Re: Response to Comments, Draft Feasibility Study Report, OU  
Number 6 (Sites 36 and 54), MCB Camp Lejeune, N.C.

**RESPONSE TO COMMENTS  
DRAFT FEASIBILITY STUDY (FS) - SITES 36, 54, AND 86  
OU NO. 6, CTO 303**

**North Carolina Department of Environment, Health and Natural Resources (NC DEHNR)  
Comments Dated August 6, 1996**

DETECTED LEAD IN SURFACE SOILS,  
SUBSURFACE SOILS, AND SEDIMENTS  
SITE 36, CAMP GIEGER AREA DUMP

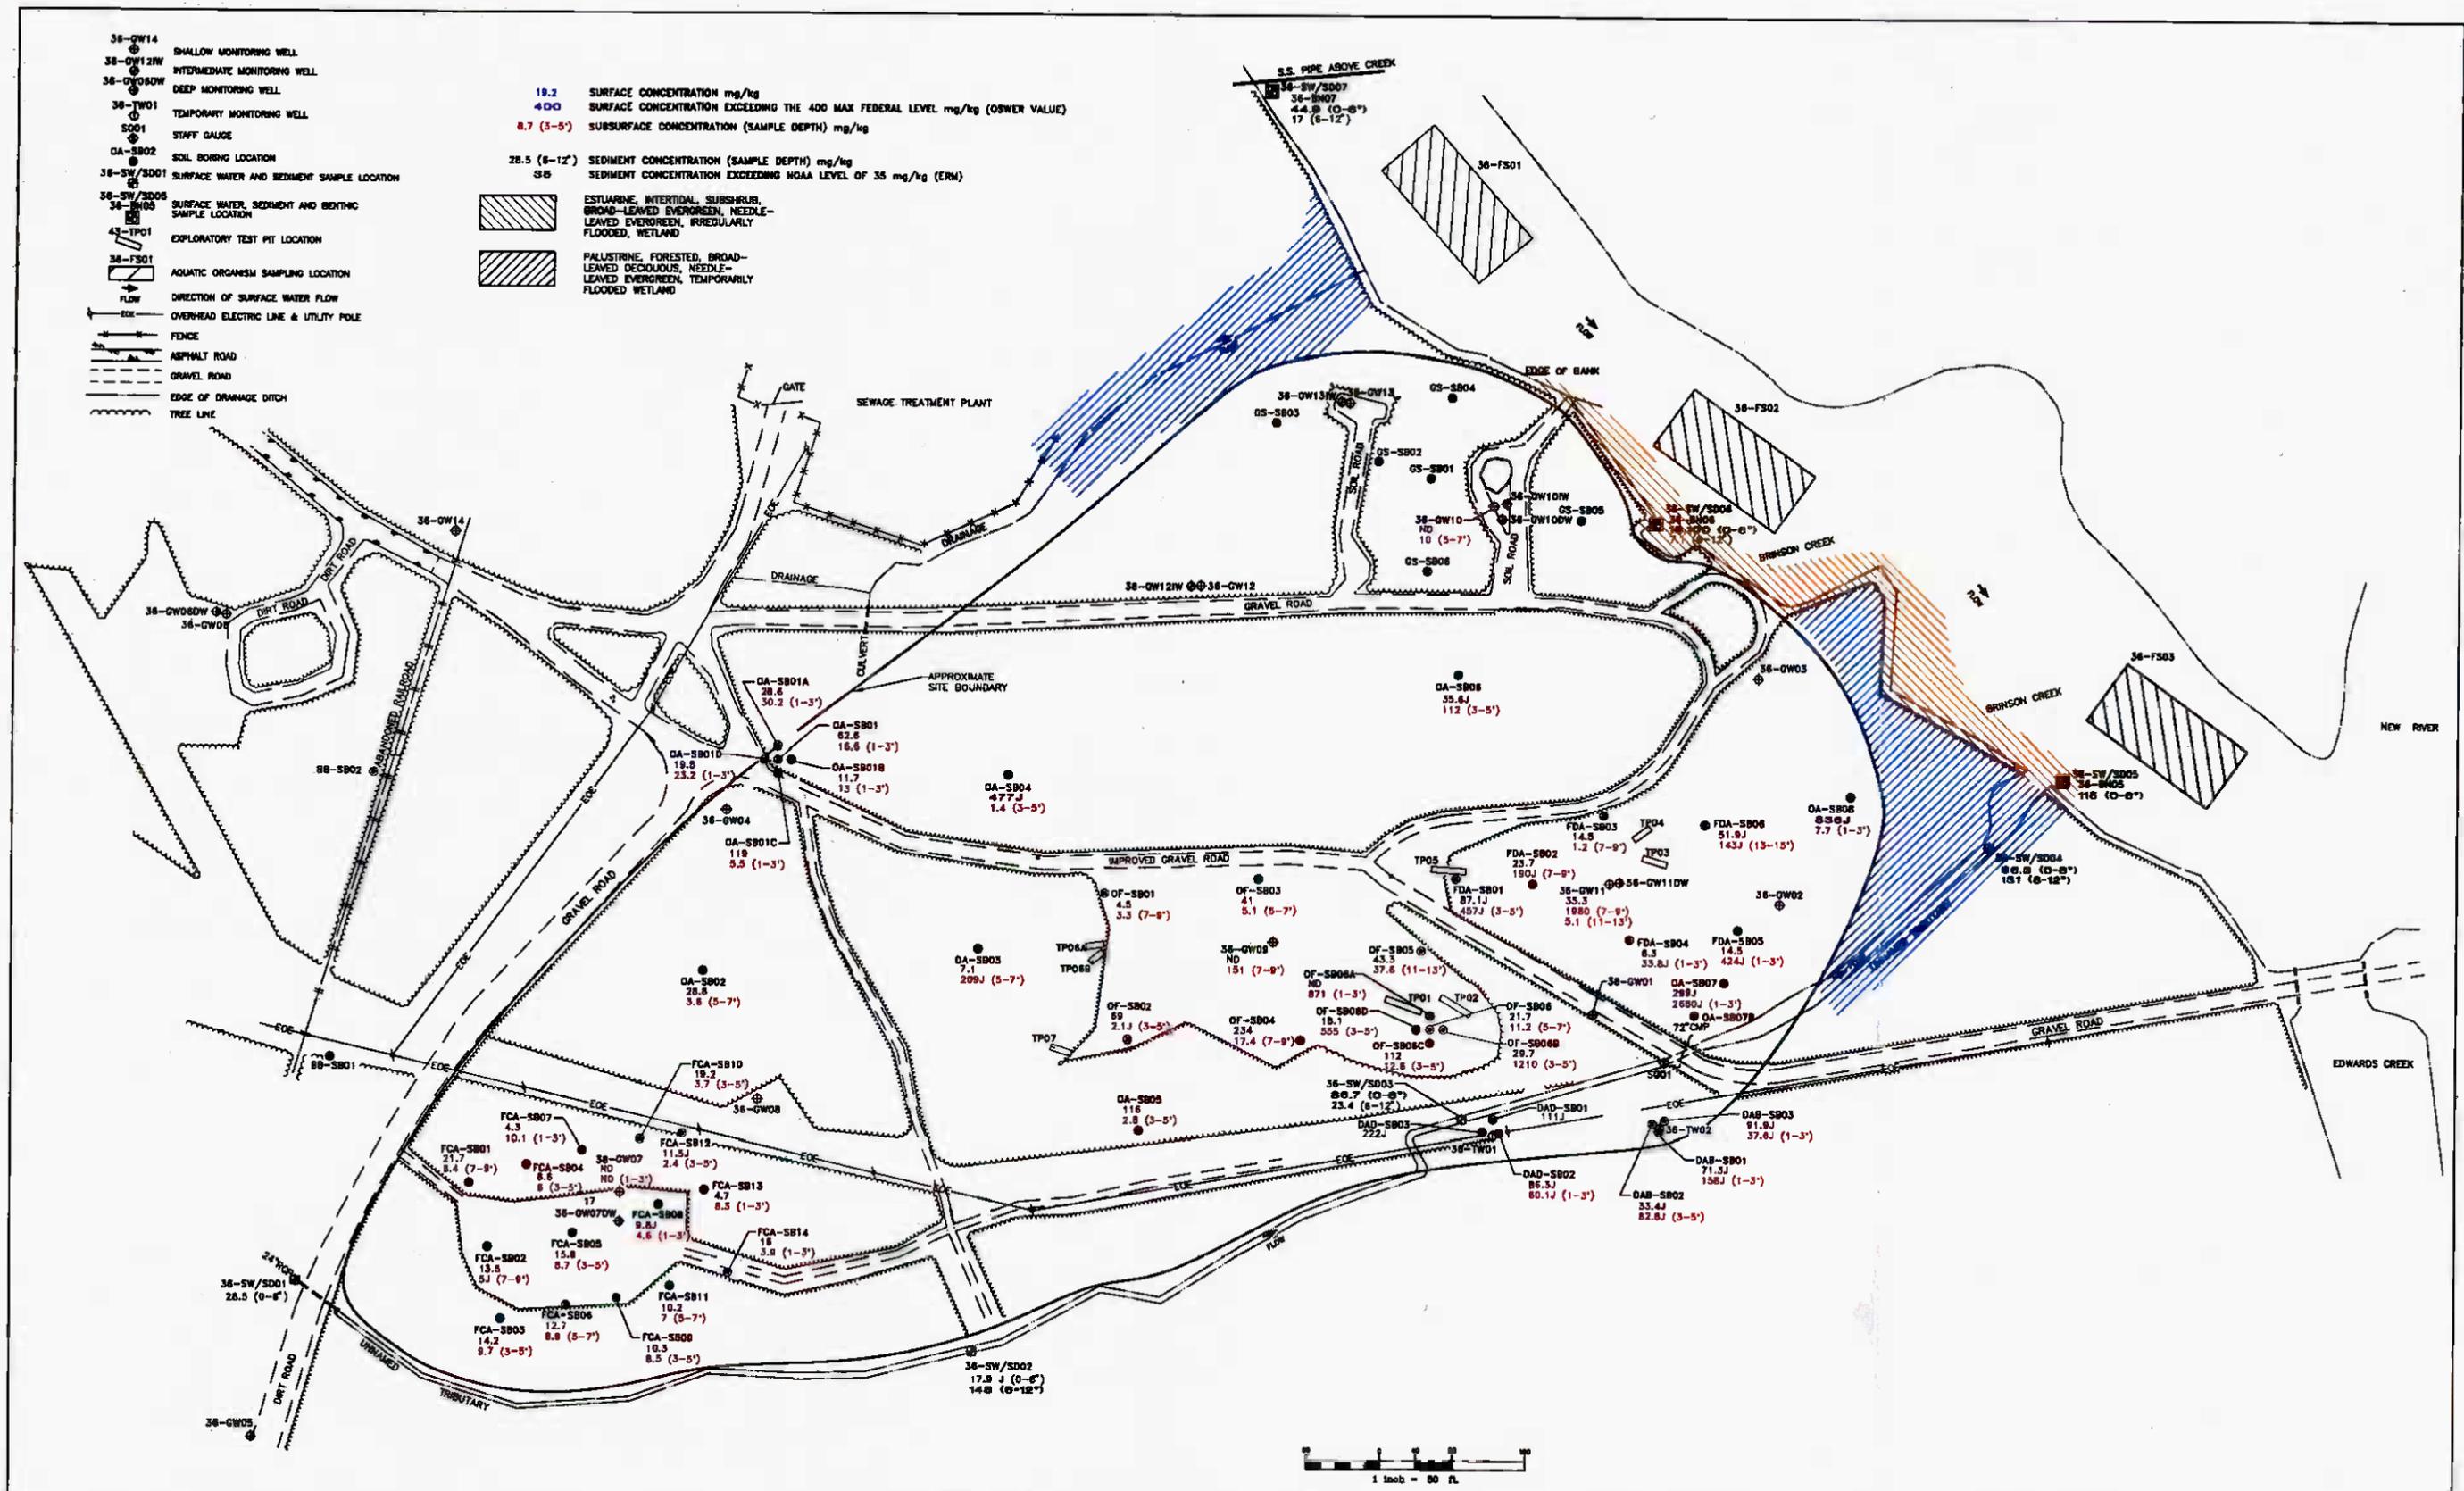
Figure C identifies the lead levels detected in surface soils, subsurface soils, and sediment. This figure will be included within the Final FS. As shown, surface soil detections at OA-SB04 and OA-SB08 were in excess of the OWSER value of 400 mg/kg for surface soil. These elevated surface soil detections are located approximately 920 feet apart; and therefore, do not identify a pattern of surface soil lead contamination. In addition, Section 6.8.3 of the Final RI identifies a range of natural lead levels in soil from 2 to 200 mg/kg and several literature values of street dust lead detections (from residential and commercial areas) of 1,000 to 2,400 mg/kg. Similar comparisons to site media are discussed for lead detected in shellfish, fish and other food. This comparison supports the conclusion that further action at Site 36, due solely to lead in soils and crab tissue, is not warranted.

8. A risk evaluation for exposure to surface soil under the future residential scenario was completed and included within the Final RI (see Section 6.3.1). In addition, a comparison of typical levels of iron in similar media to the maximum iron concentrations detected on site was conducted. This comparison will be added to the Final FS.
9. As shown on Figure C, the locations of the elevated lead within the surface soil and the location of

the highest lead detection in sediment (36-SW/SD06) are in two different topographic flow areas. The majority of the elevated lead detections in soil were encountered in the southeastern and south central areas of Site 36. These areas drain toward the unnamed tributary, which converges with Brinson Creek approximately 700 feet down stream of sediment station 36-SW/SD06. Thus, it is unlikely that the elevated soil concentrations at Site 36 are the source of the elevated lead detection in sediment due to the different topographic flow areas. In addition, the sediment located immediately adjacent to 36-SW/SD06 was resampled and the results indicated lead concentrations below the 35 µg/kg screening value. Therefore, the conclusion that the original sediment detection of lead may be an anomaly still applies. Note that attached Figures A, B, and C will be added to the Final FS.

GROUNDWATER FLOW AND  
 SELECT CONTAMINANT DISTRIBUTION  
 PATTERNS IN CROSS SECTION D-D'

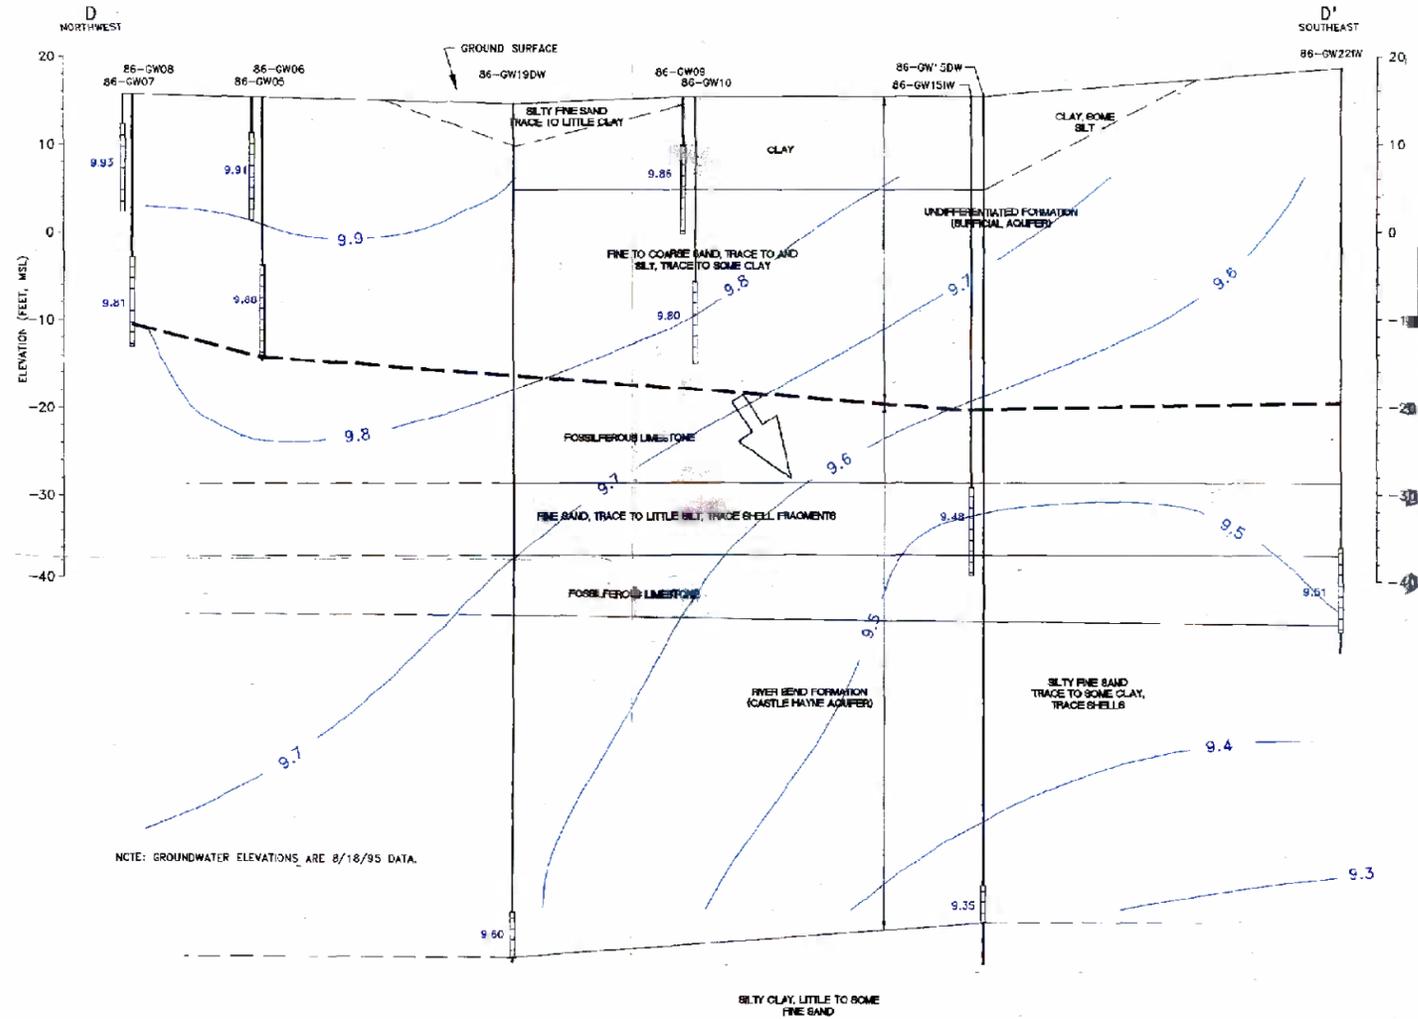
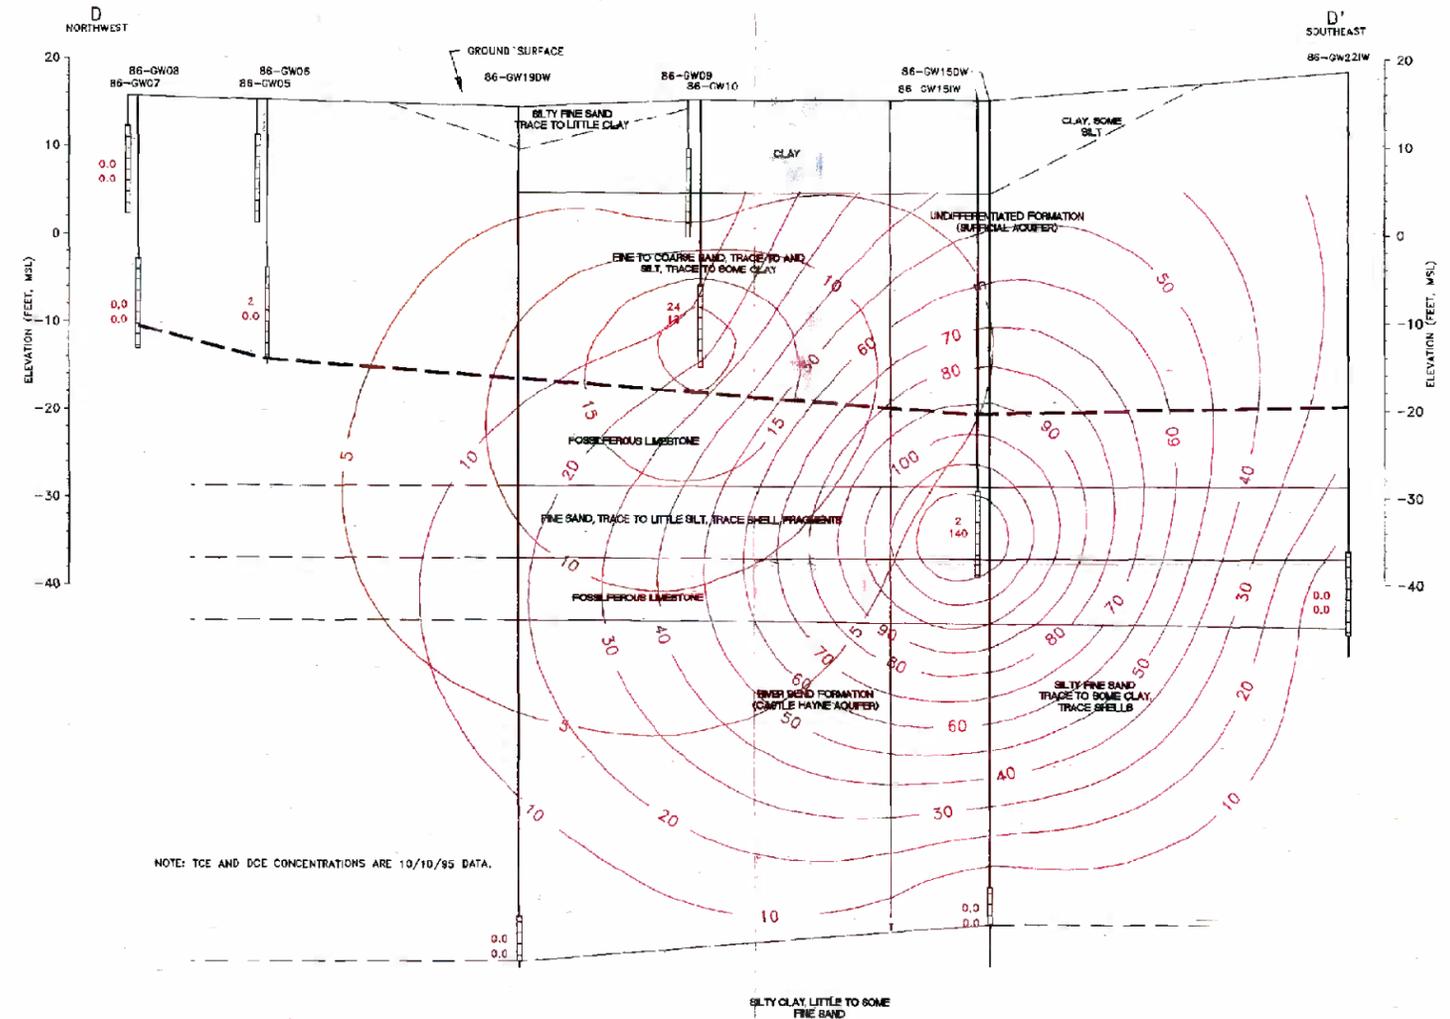
Figure 1 contains cross-section D-D' from the Baker RI report. Section D-D' runs perpendicular to the groundwater flow of the Castle Hayne aquifer (Figure 2). Groundwater elevations from May 1995 and their corresponding iso-elevation contour lines are displayed on the left-hand cross-section. TCE and DCE concentrations from October 1995 and their corresponding iso-concentration contour lines are displayed on the right-hand cross-section.

These cross-sections provide evidence that the source of the VOC groundwater contamination originated within the Site 86 boundary. The left-hand section supports the RI conclusion that the Site 86 area is a recharge area exhibiting a downward flow potential. Moreover, this section shows that at least in May 1995, there is a southeastern component to the downward flow potential. Note that on the right-hand cross-section the DCE plume is slightly downgradient of the TCE plume, with respect to the groundwater flow potential. DCE is a more mobile daughter product of TCE. Accordingly, the contaminant distribution of TCE and DCE appear to be the result of the downward flow components.
